# Preliminary Consultation MONTGOMERY COUNTY HISTORIC PRESERVATION COMMISSION STAFF REPORT

Address: Multiple Addresses, Clarksburg Meeting Date: 2/12/2020

**PROPOSAL:** Shared-use path

The applicants propose to construct an 8' wide shared-use path along the east side of MD 355 (Frederick Road) within the Clarksburg Historic District. The proposal also includes intersection improvements, tree removal/planting, and streetlamp installation.

RW1-1

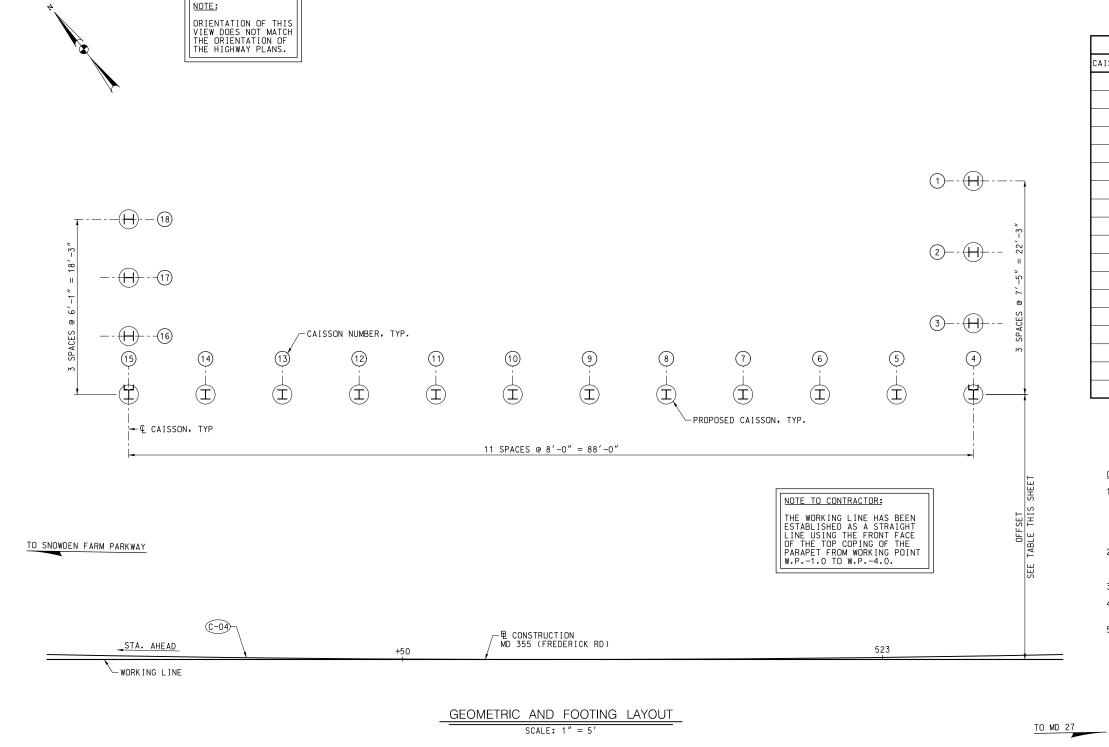
Staff asks that the applicants clarify the materials of the proposed retaining walls. Staff finds that retaining walls with stamped concrete or cultured stone veneers are not successful in most historic districts. Traditional materials – stone, parged concrete block, poured concrete – would be more appropriate for retaining walls within the Clarksburg Historic District. Staff also requests additional information regarding the proposed fiberglass streetlamps. Staff is mainly concerned about the finish of the proposed streetlamps and how the materials will weather/age.
